RE: 9678-N

RE: License No. SUB-1010; Docket No. 40-8027
Revisions to Amendment Application Submitted on July 19, 1994

ATTACHMENT 1
SUMMARY OF CHANGES
Page 1 of 2

SEQUOYAH FUELS CORPORATION			
TITLE: SEQUOYAH FACILITY GENERAL ARRANGEMENT			
PREPARED BY: SFC		FILENAME: NRC0002A	
REVIEWED BY: CH		FIGURE NO. J-1	
DATE: 09/24/96

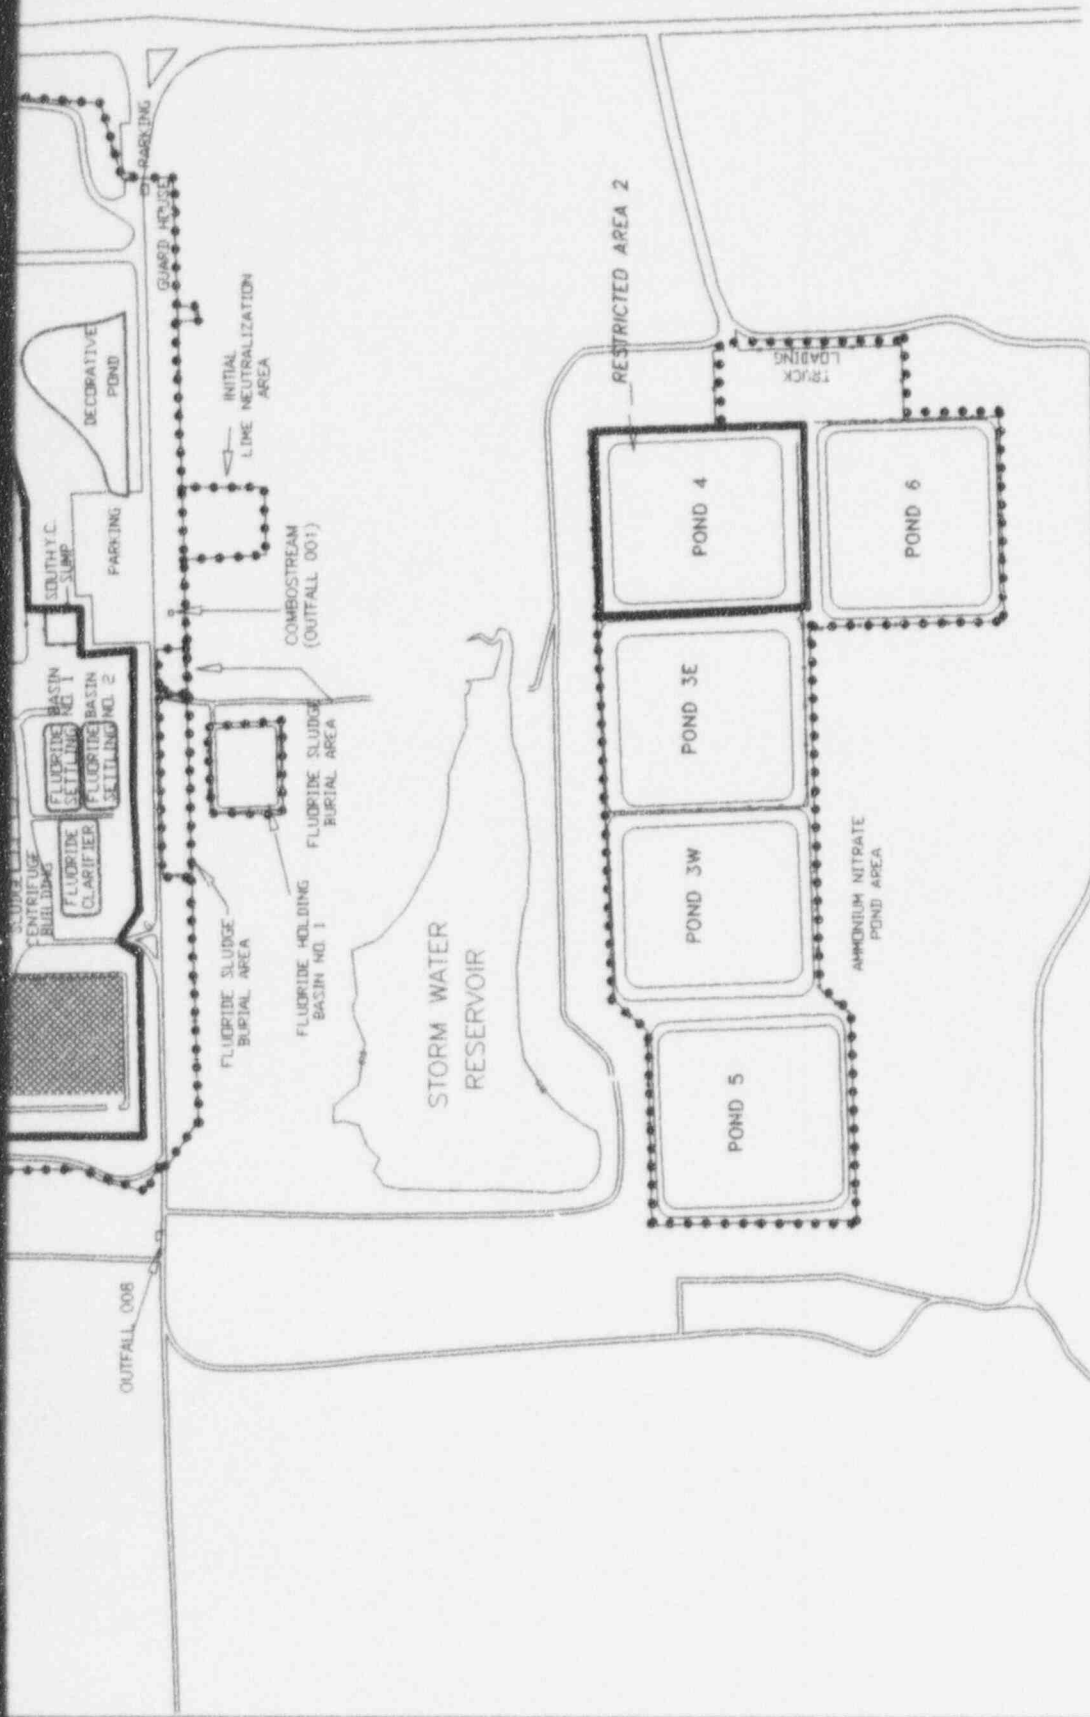
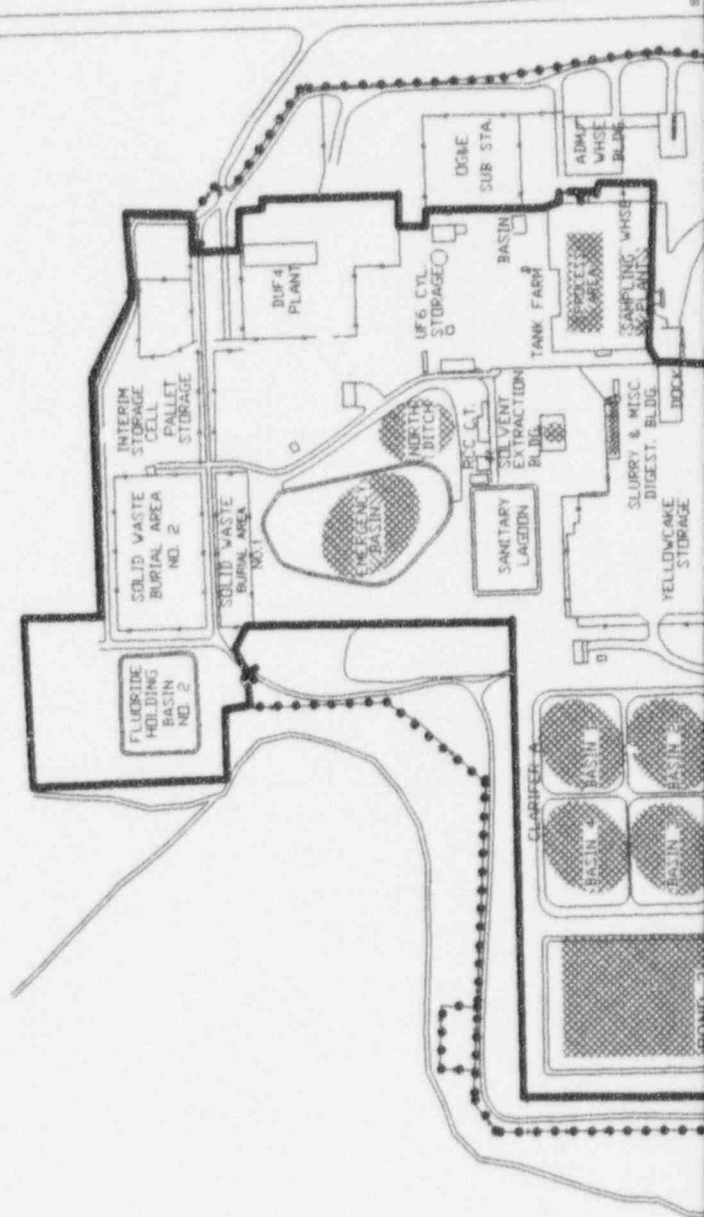
1. The definition of "Sequoyah Facility" in Section 1.6 was revised to reflect the correct figure number and the facility as represented in the License.

6. The title of Figure 3-1 has been changed back to "Sequoyah Facility General Arrangement."
7. Subsection 3.3.1.1 has been revised to remove the reference to the Guard House.
